**ADDENDUM NO. 2**

Date of Addendum: February 7, 2023

Project Name: Gaston County Schools – Grier Middle School

- A. Owner: Gaston County Schools
- B. Architect: LS3P
- C. Architect Project Number: 9201-218240

T-701

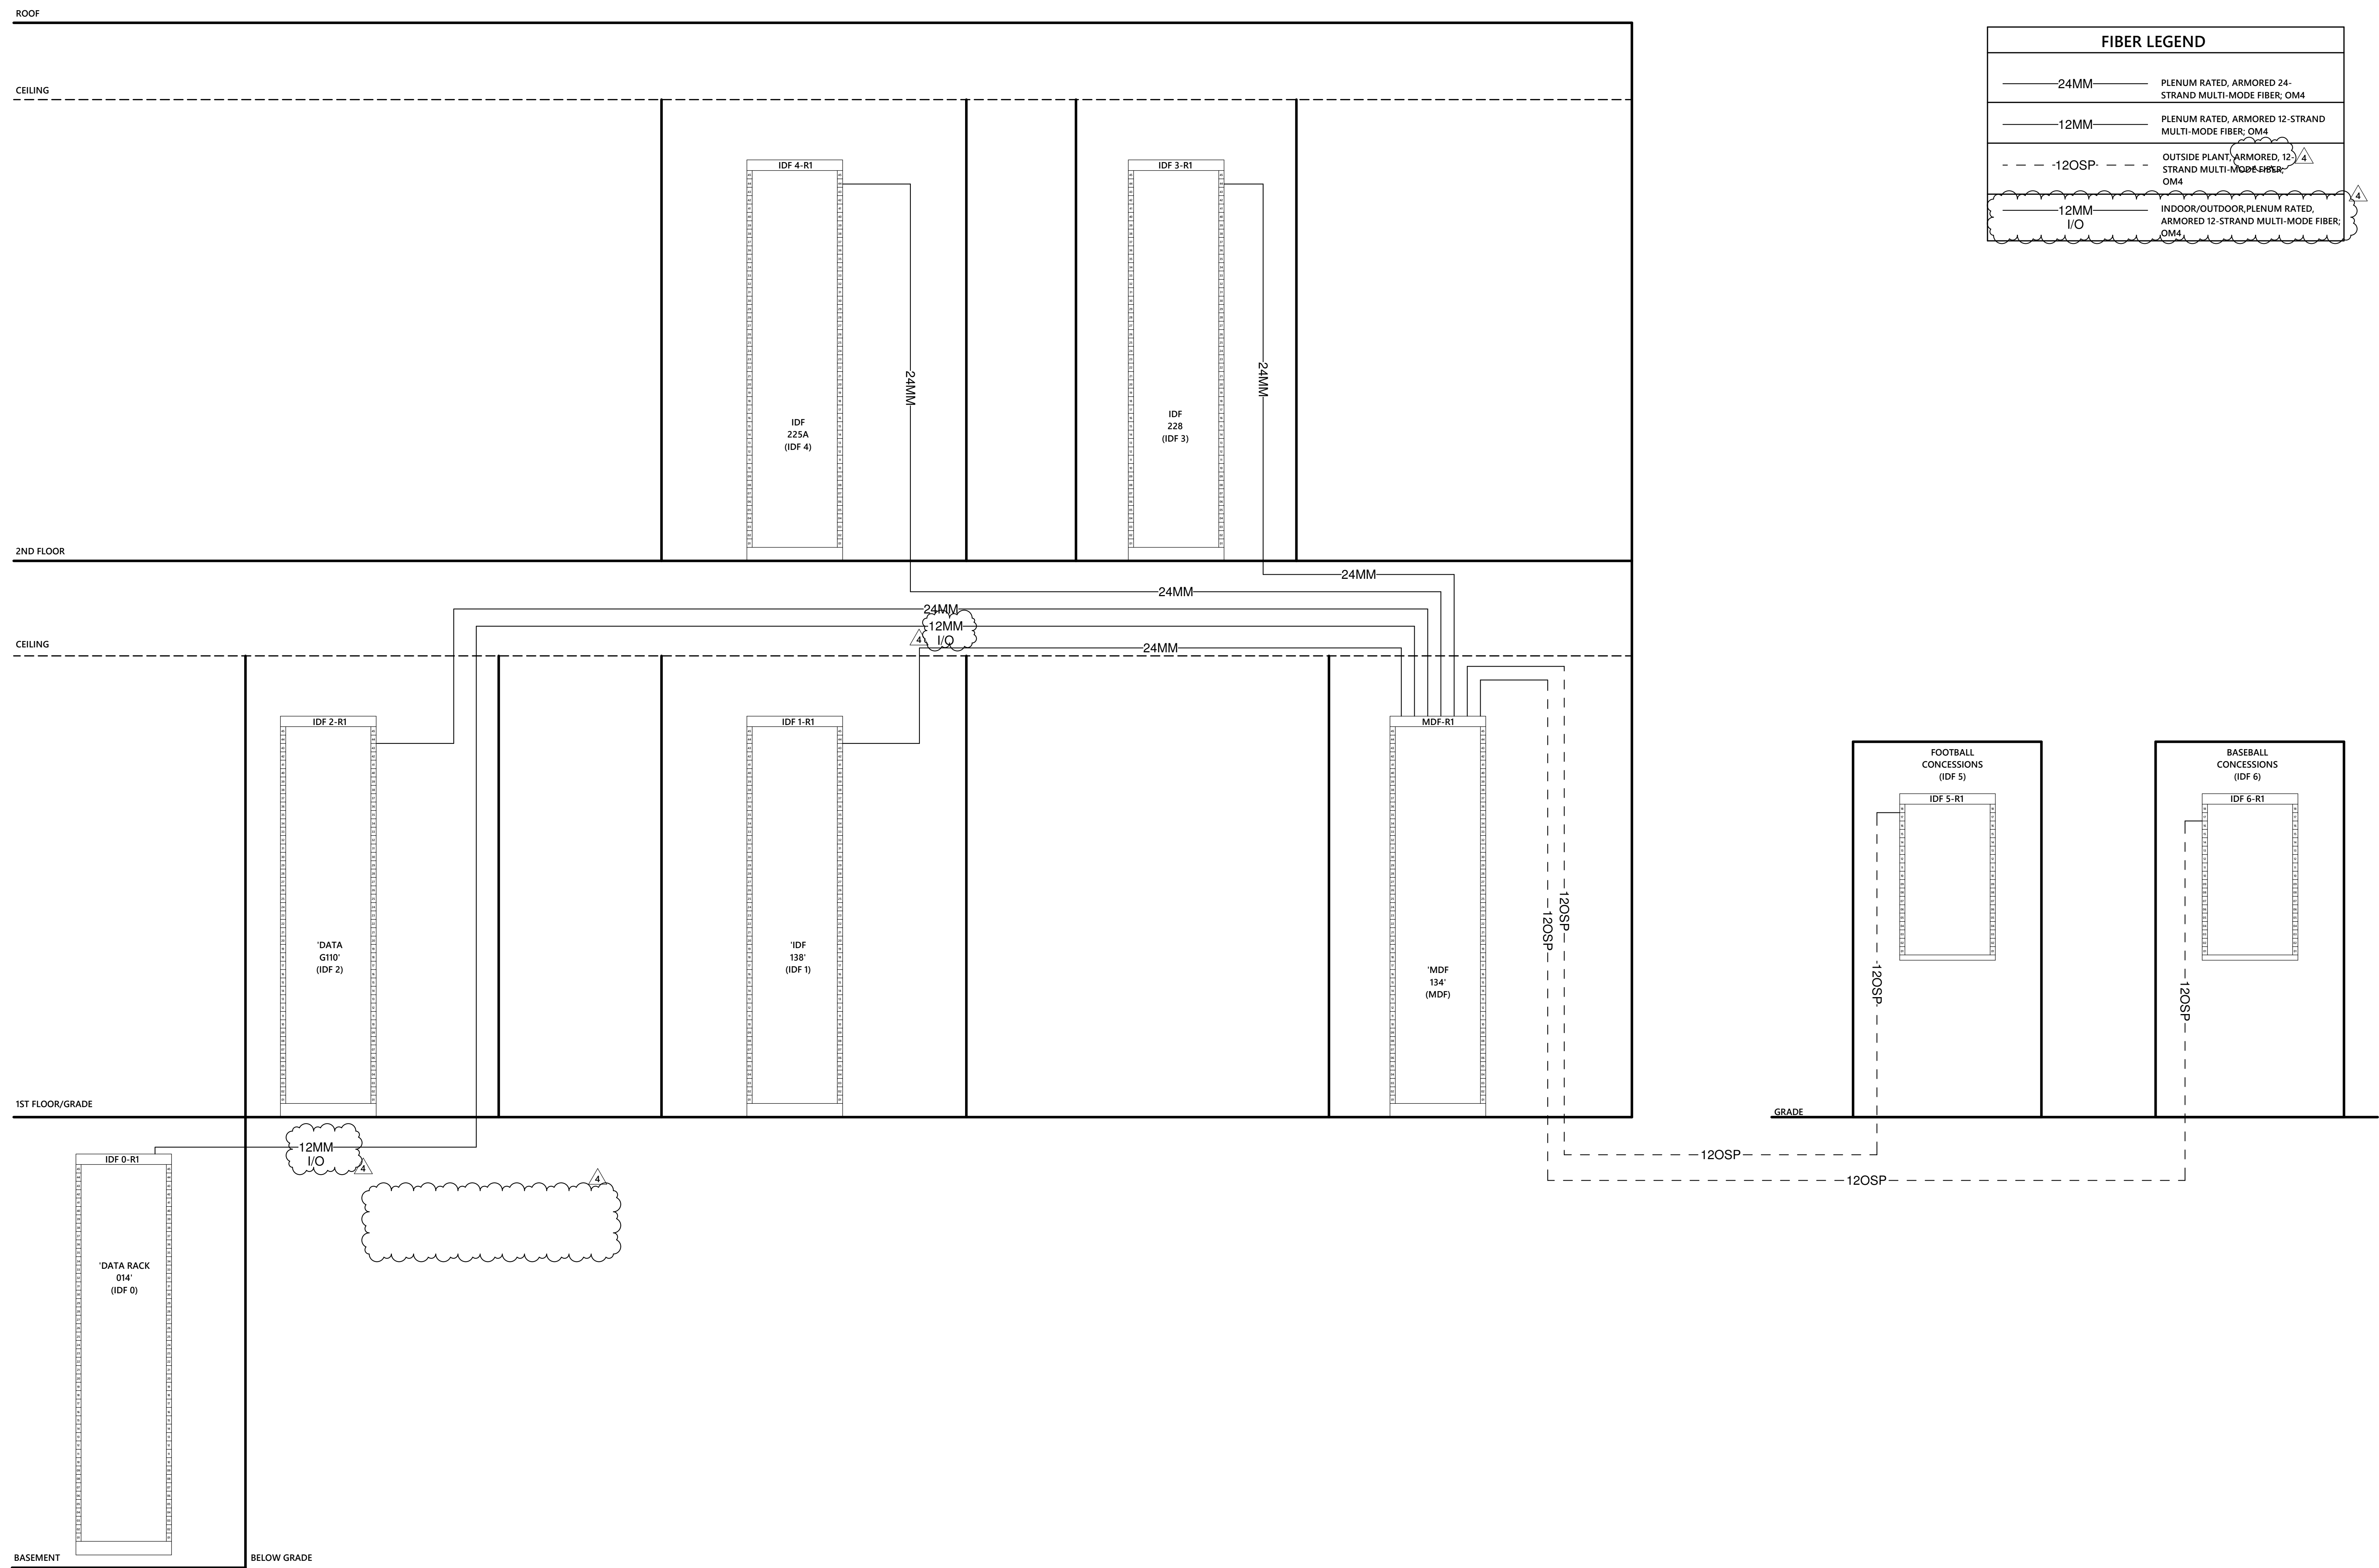
1. Fiber serving Basement IDF revised to I/O Fiber, Outdoor fiber now armored.
- EE. Replace SHEET T-702 – TECHNOLOGY RISER DIAGRAMS with revised Sheet T-702, included in the attachments.

**1** FIRST FLOOR DATA NETWORK PLAN - AREA C  
1/8" = 1'-0"

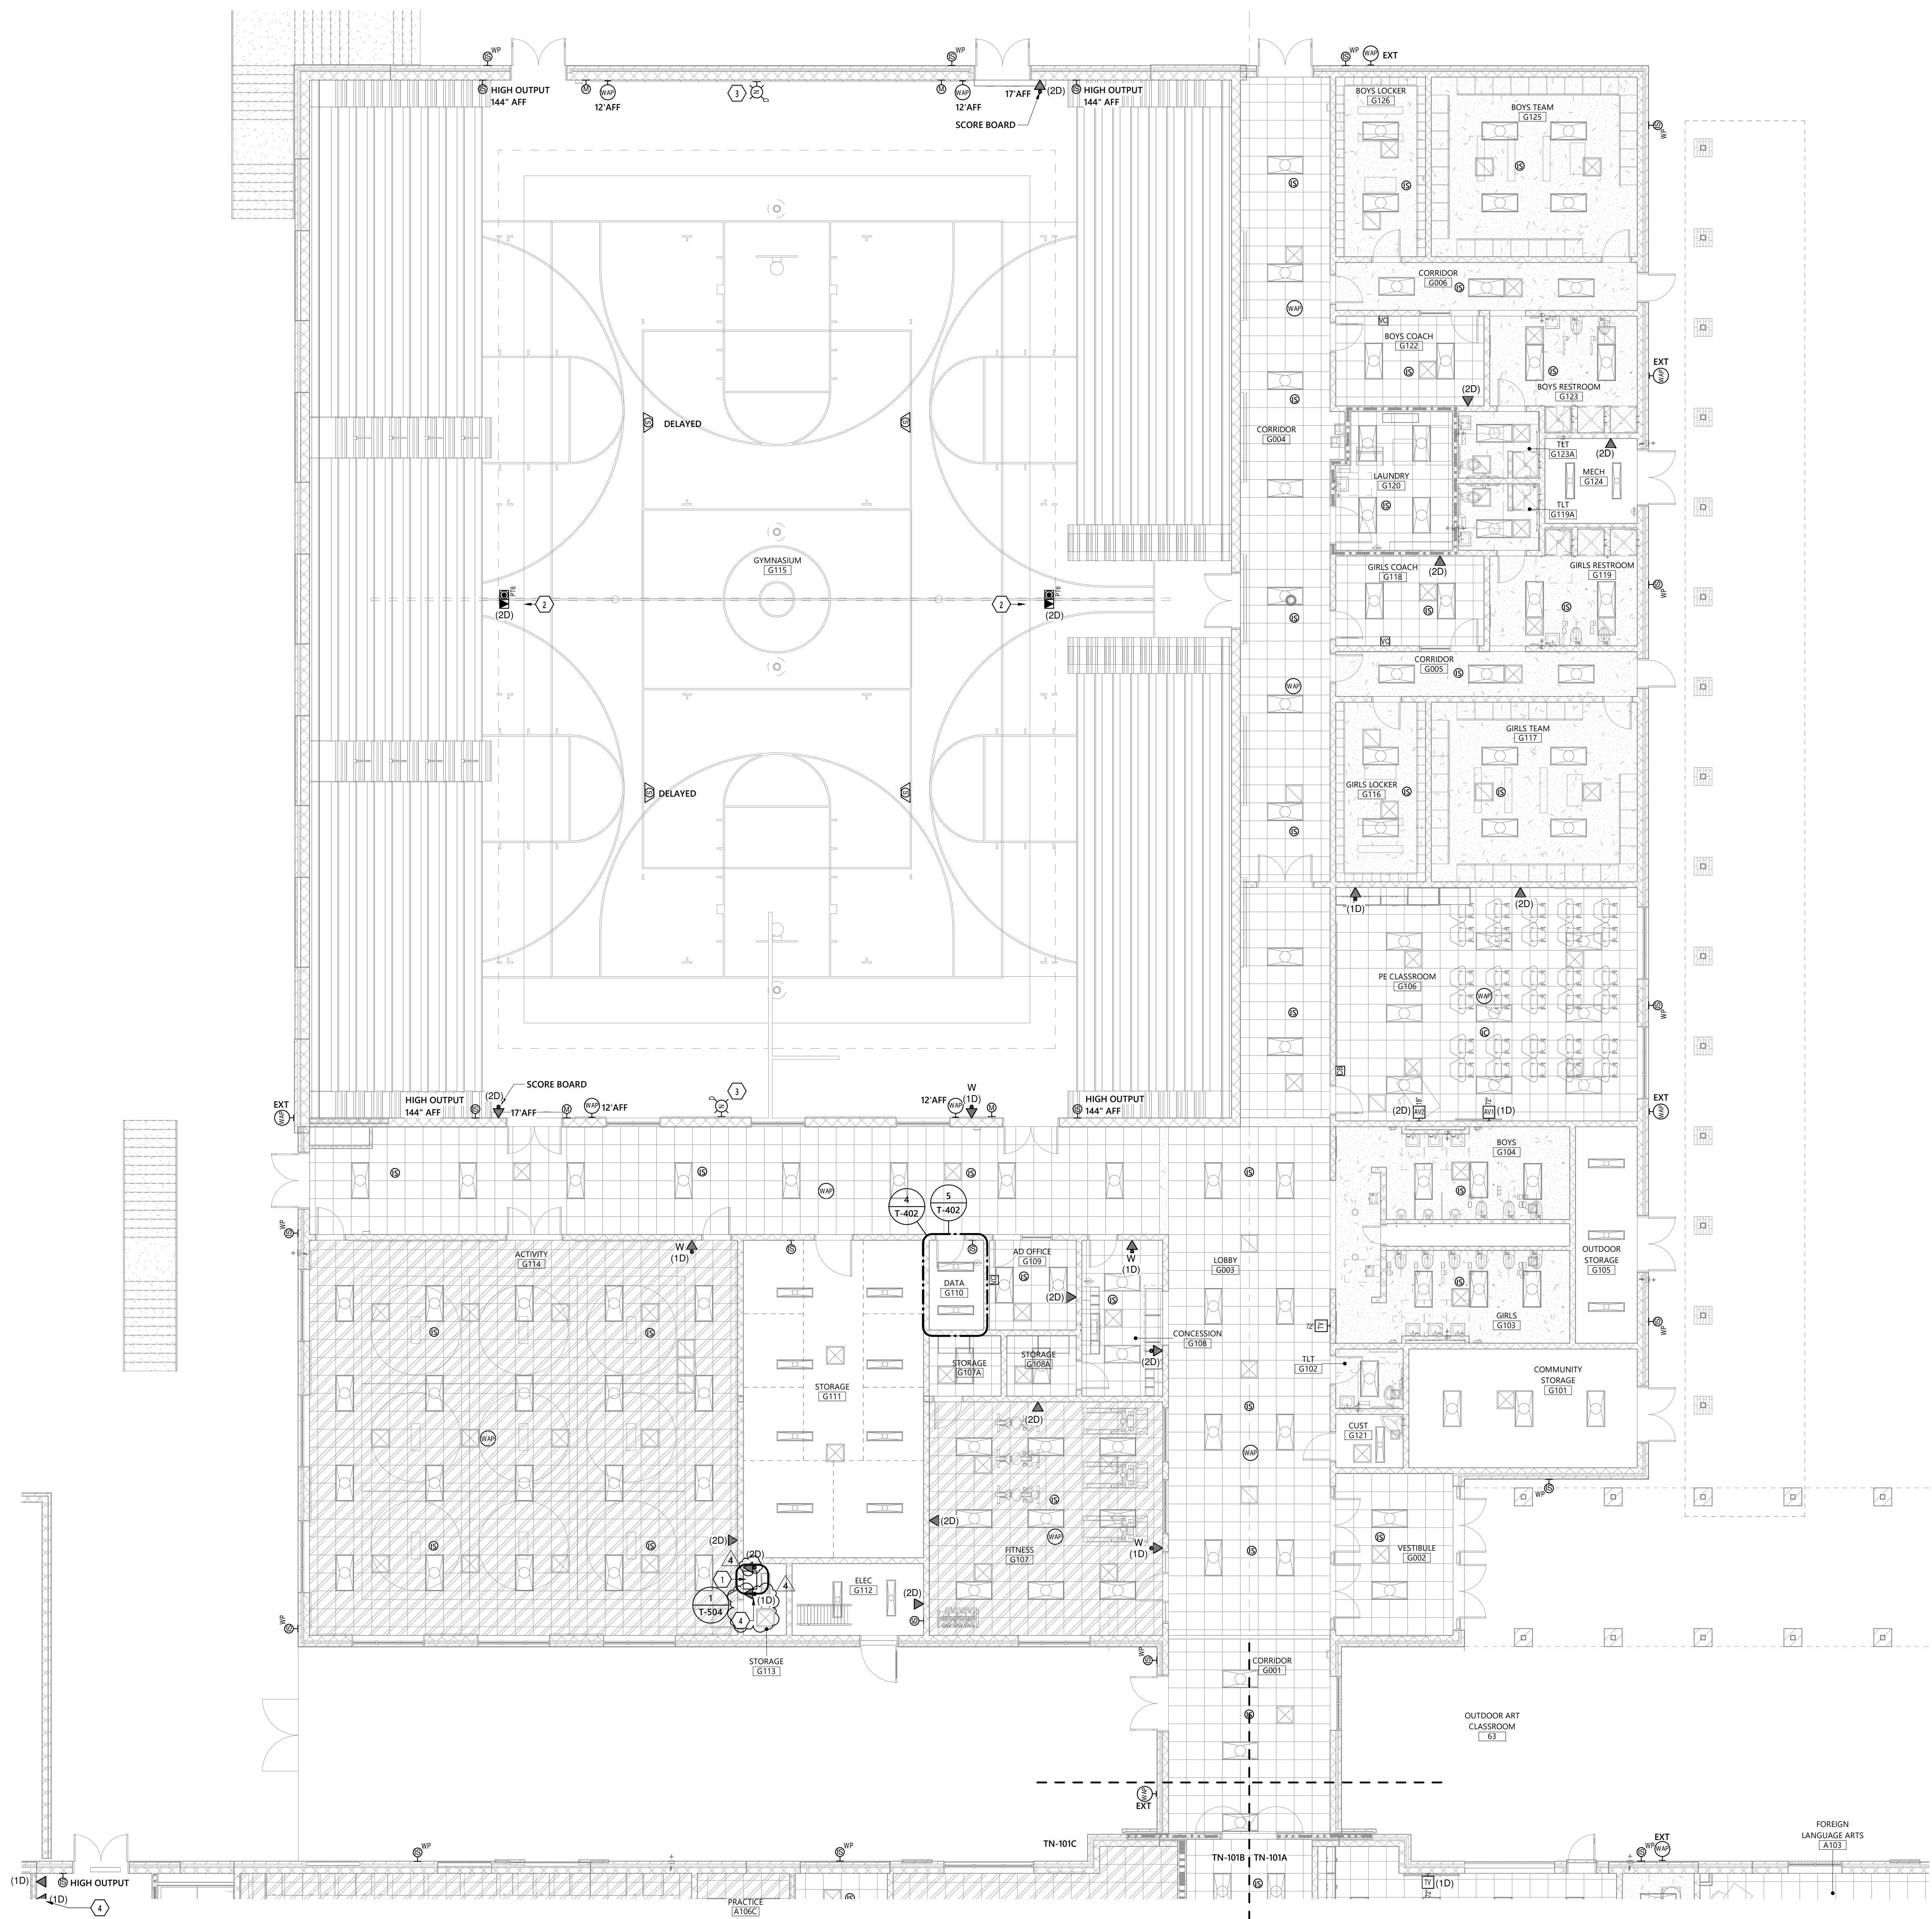
- HH. Replace SHEET TN-101C – FIRST FLOOR DATA NETWORK PLAN AREA C with revised Sheet TN-101C, included in the attachments.
1. Drop added for aux module.
